ADDENDUM NUMBER 2

Bid 26-24

Bartlett Street Area Reconstruction

Issued February 2, 2024

PROJECT: BARTLETT STREET AREA RECONSTRUCTION
 TITLE: UTILITY & PROFILE PLAN
 SHEET: C-401

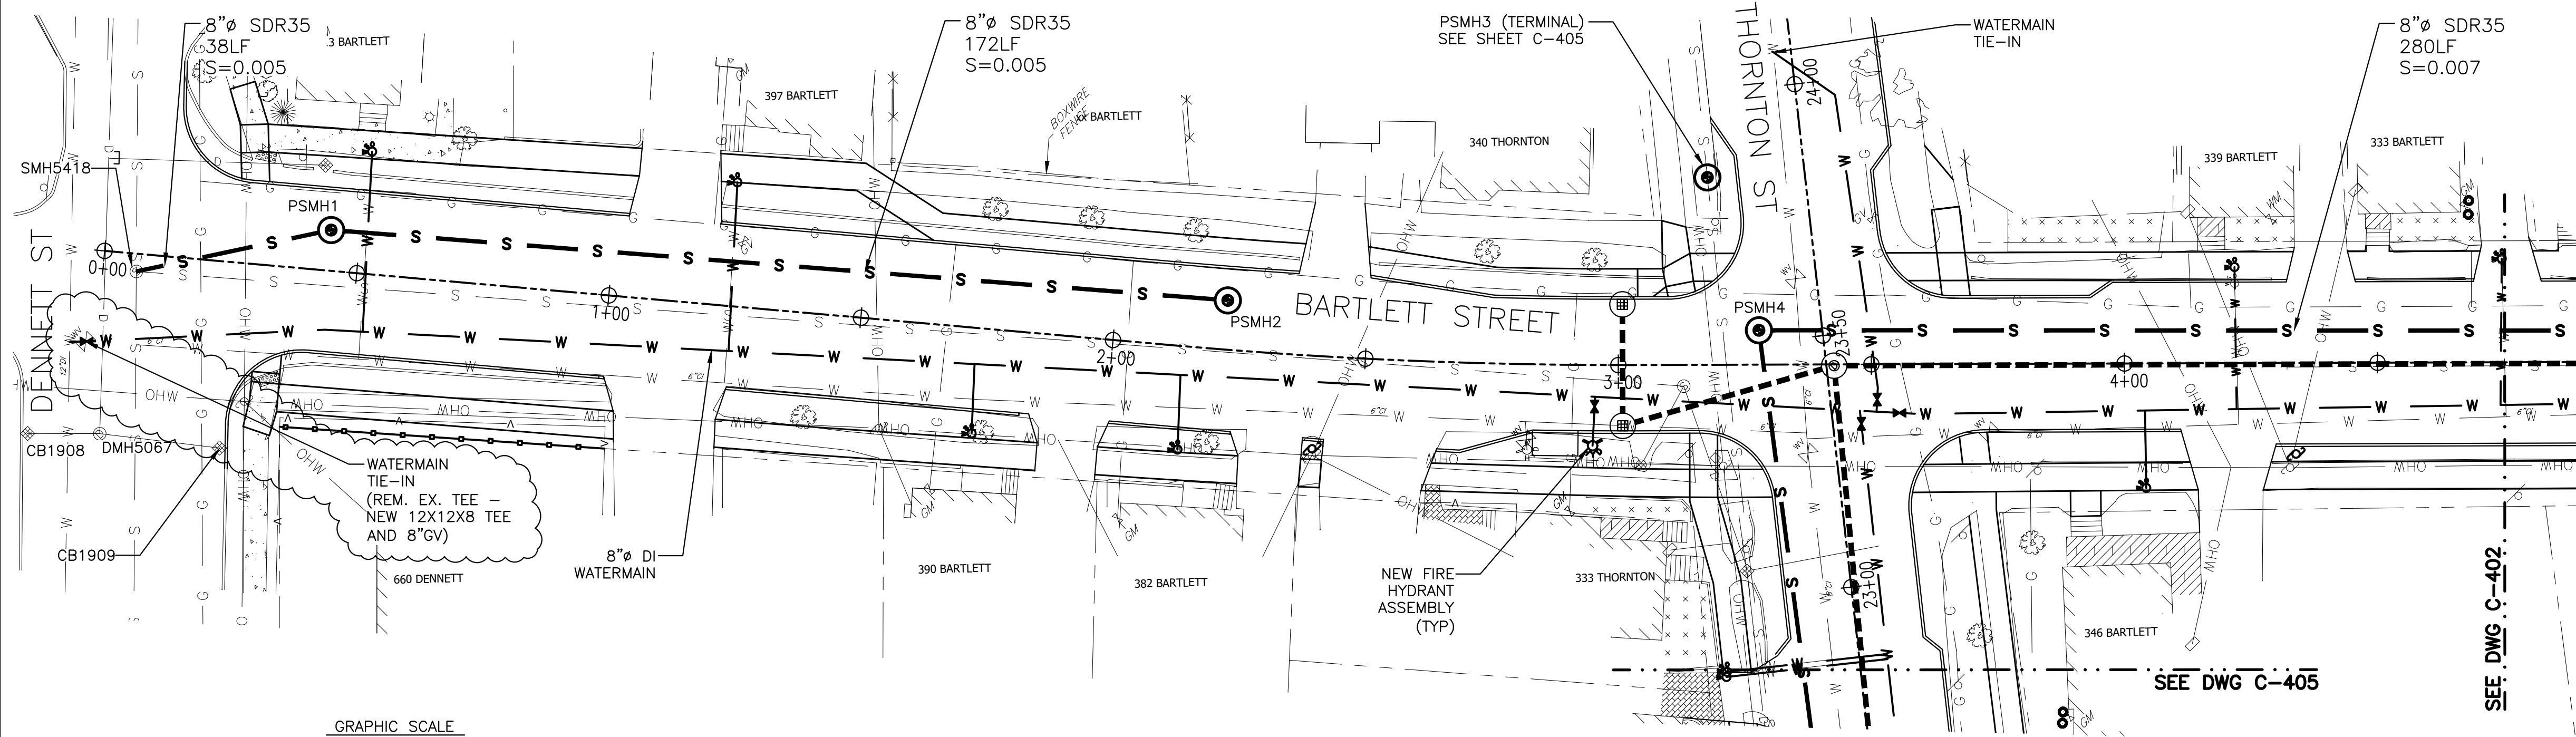
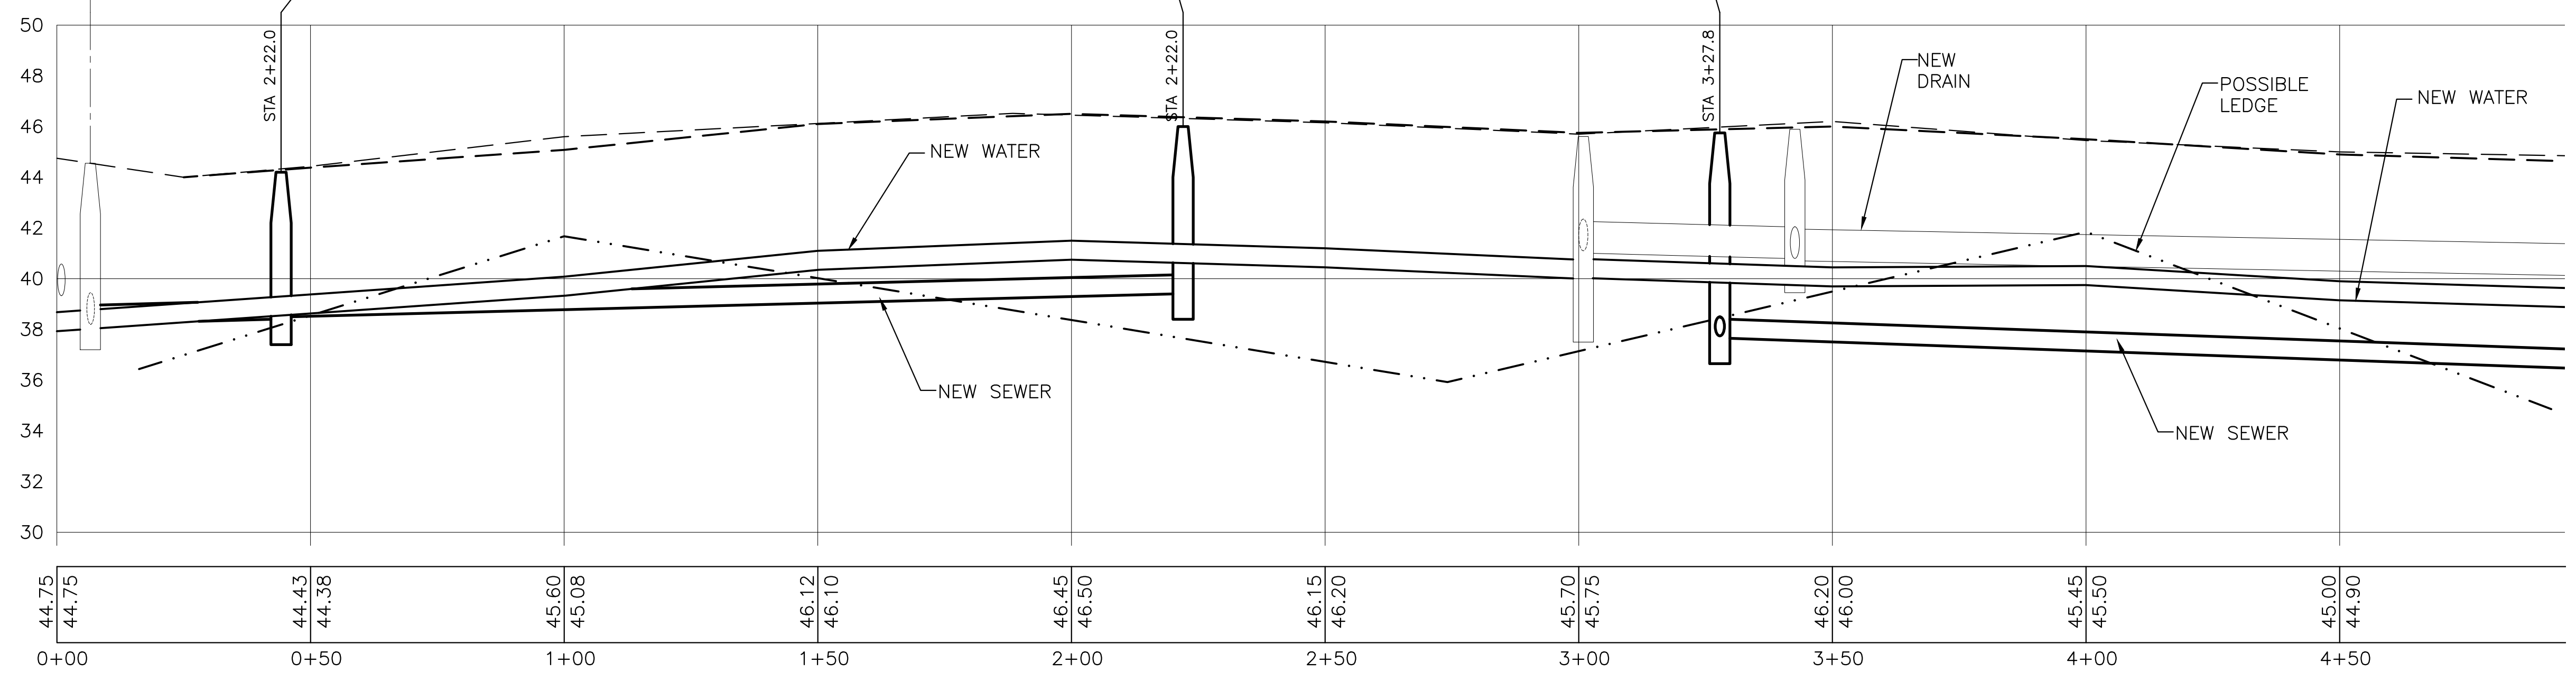
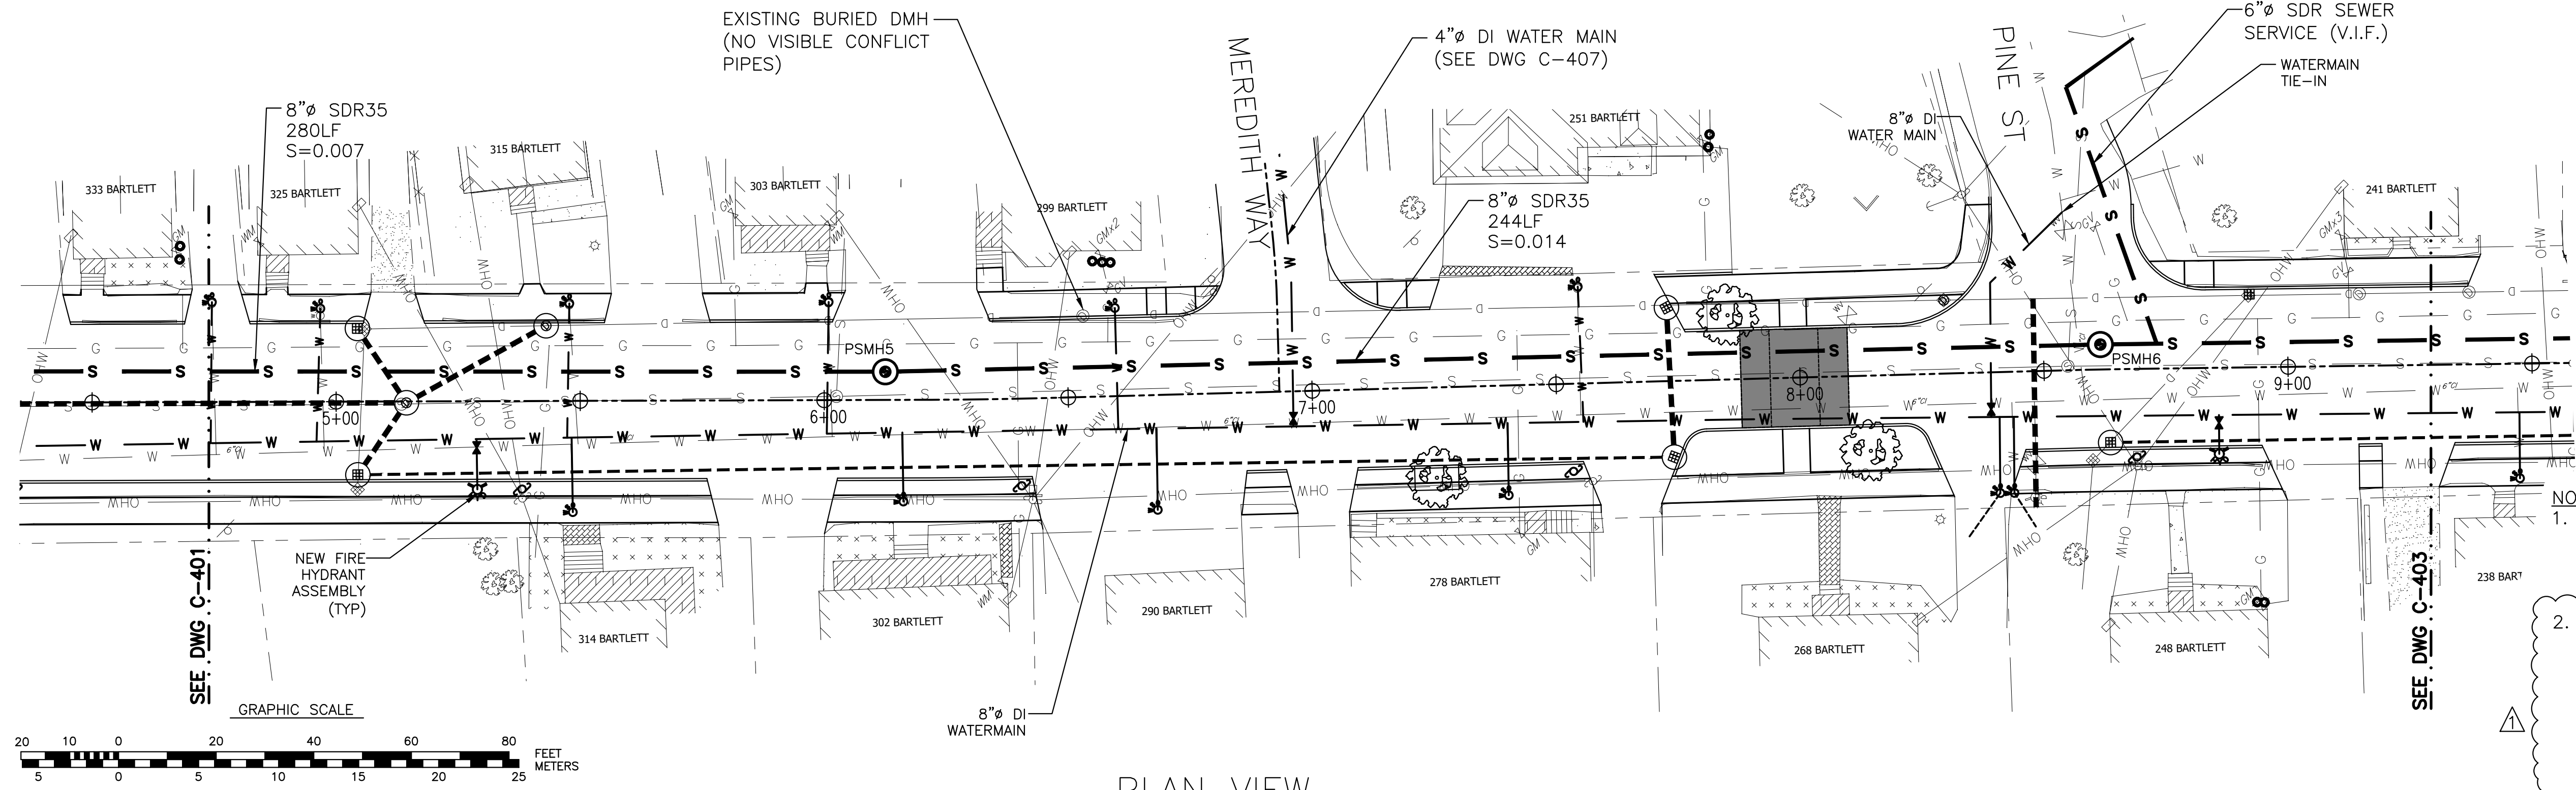
- C-401 – Clarifications were made on water tie-in at Dennett Street. Added note per NHDES request. Clarified core & boot invert information at EX-SMH5418 per NHDES request.

EX-SMH5418
 RIM=44.7
 INV IN=38.2 (6"VCP)
 INV IN=38.4 (12"VVC)
 INV OUT=38.2 (12"VVC)
 CORE & BOOT
 INV IN=38.30 (8"SDR)
 RECONSTRUCT INVERT

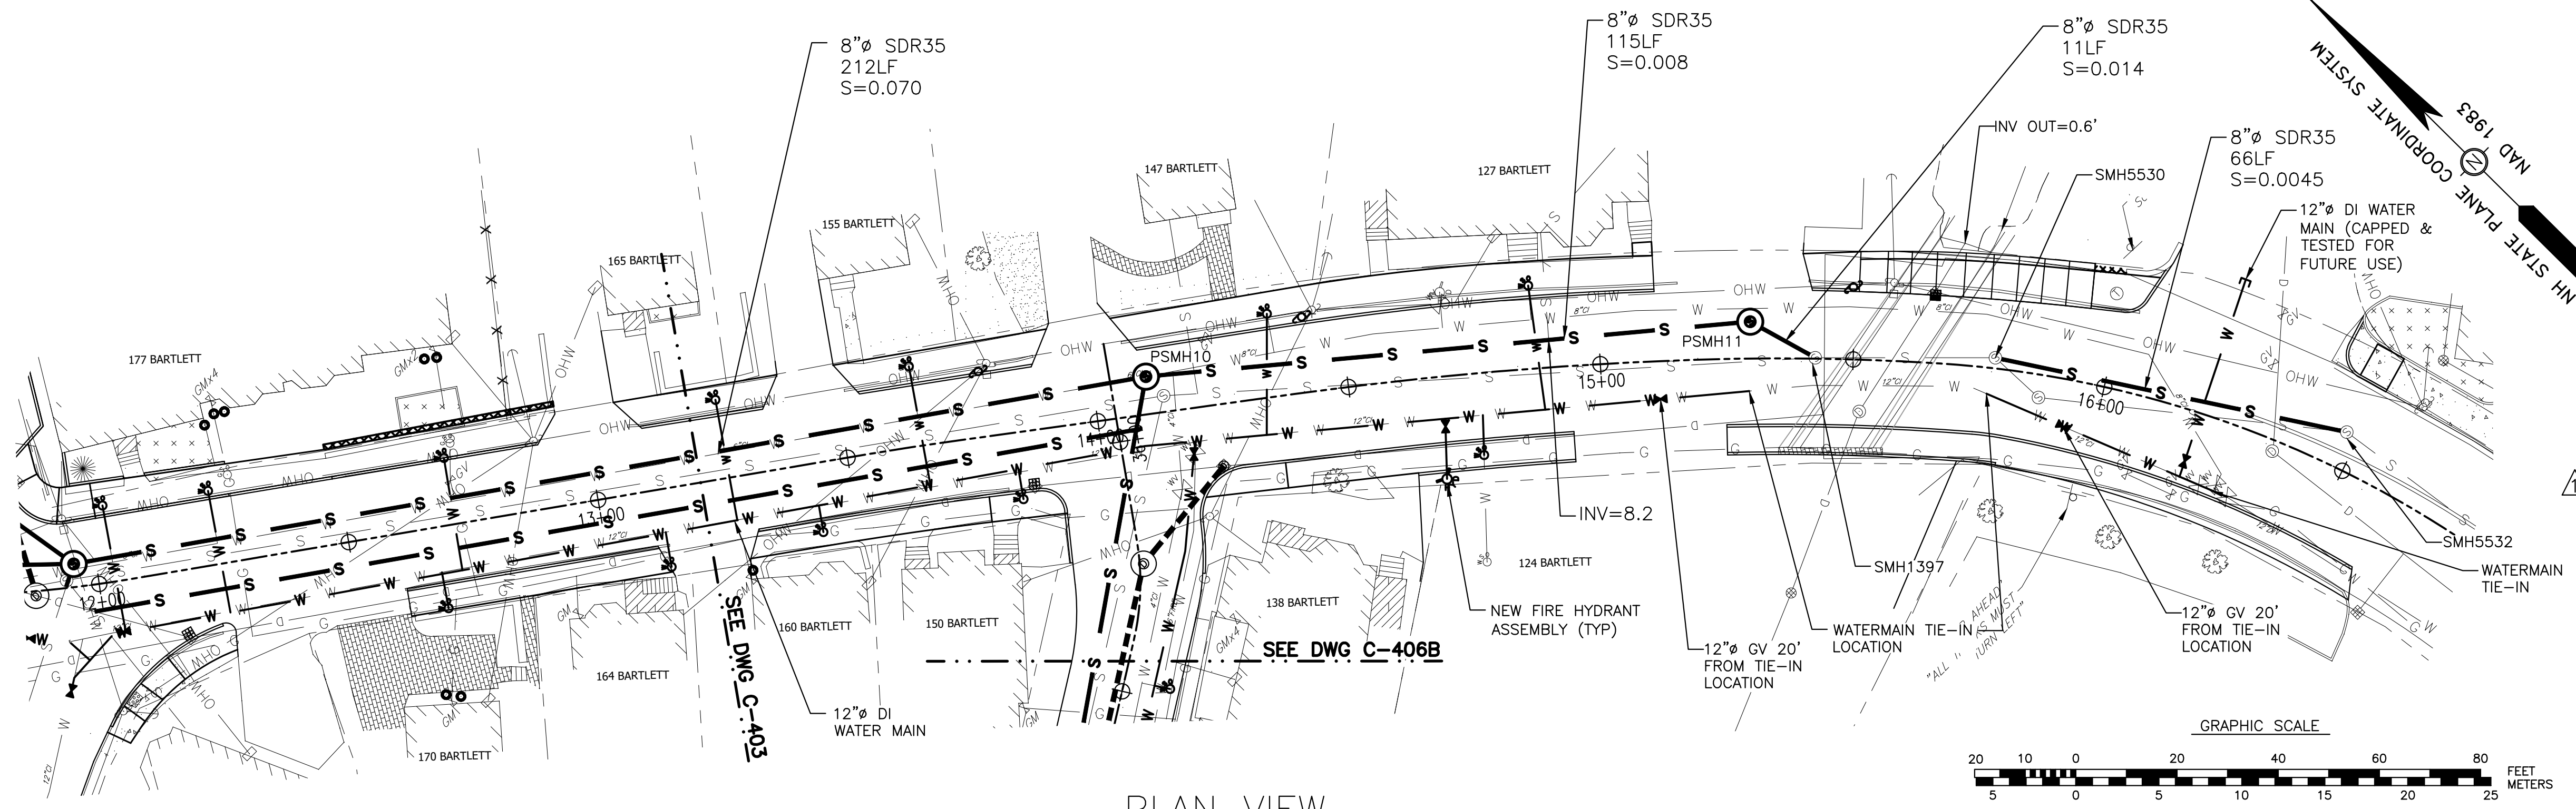
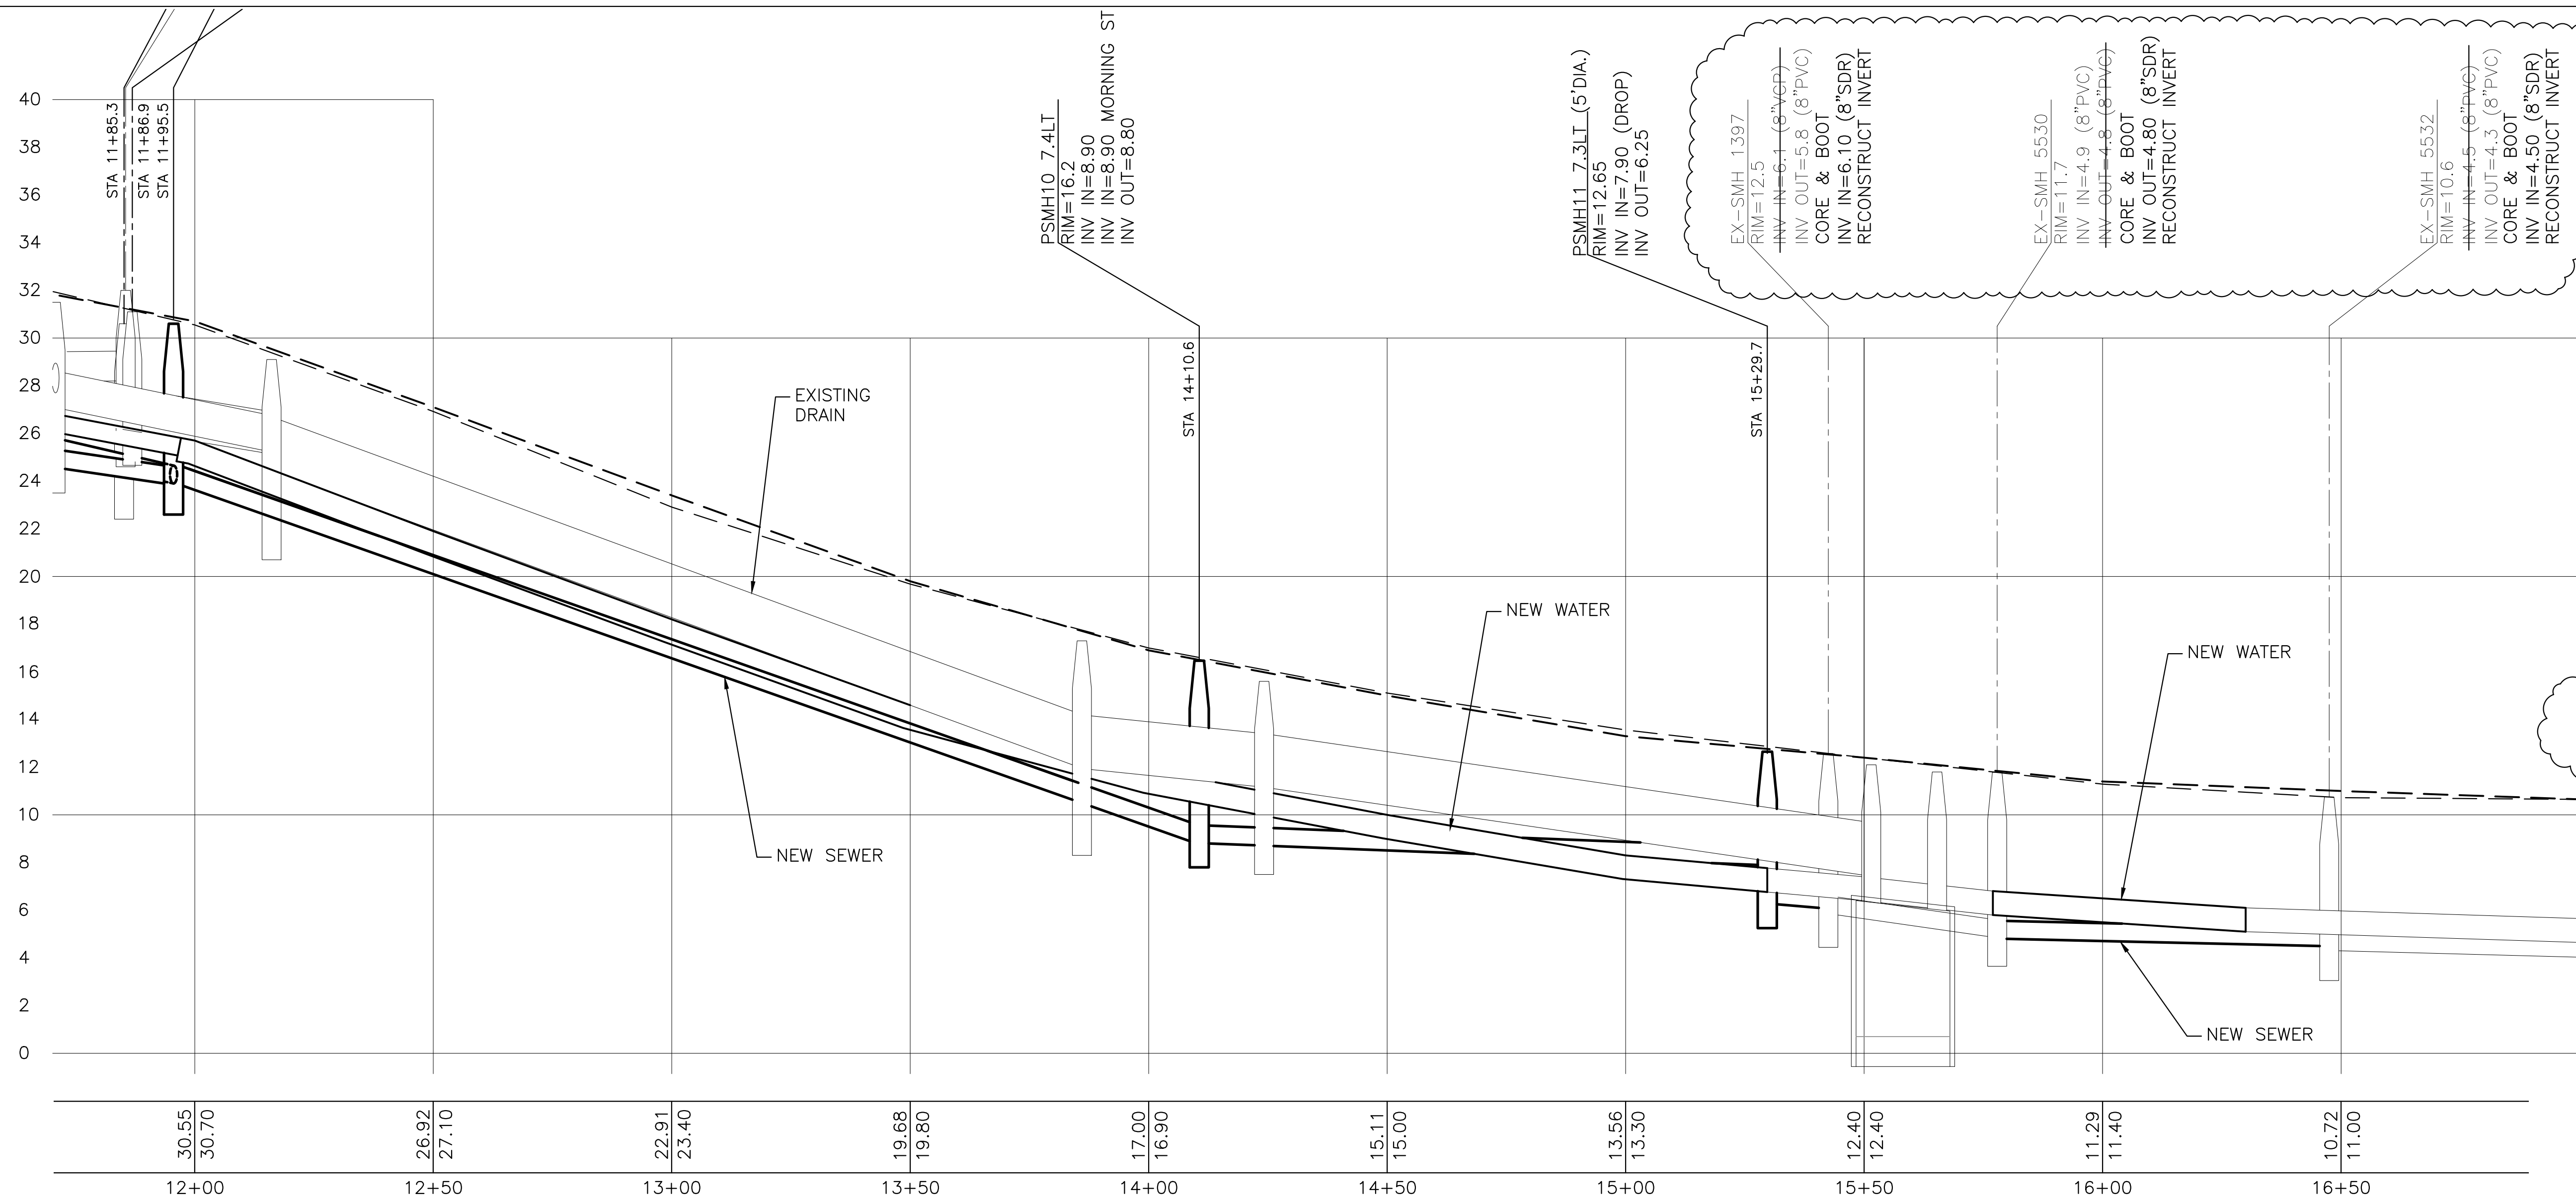
- C-404 - Added note per NHDES request. Clarified core & boot invert information at EX-SMH1397, EX-SMH5530 and EX-SNH5532 per NHDES request.
- C-405 – PSMH13 structure was identified as PSMHxx in Plan View and top of structure was shown as below grade in Profile view, both issues are corrected. Clarified core & boot invert information at EX-SMH1409 per NHDES request. PSMH3 in Profile View included an invert in elevation. There is no invert in on this structure.
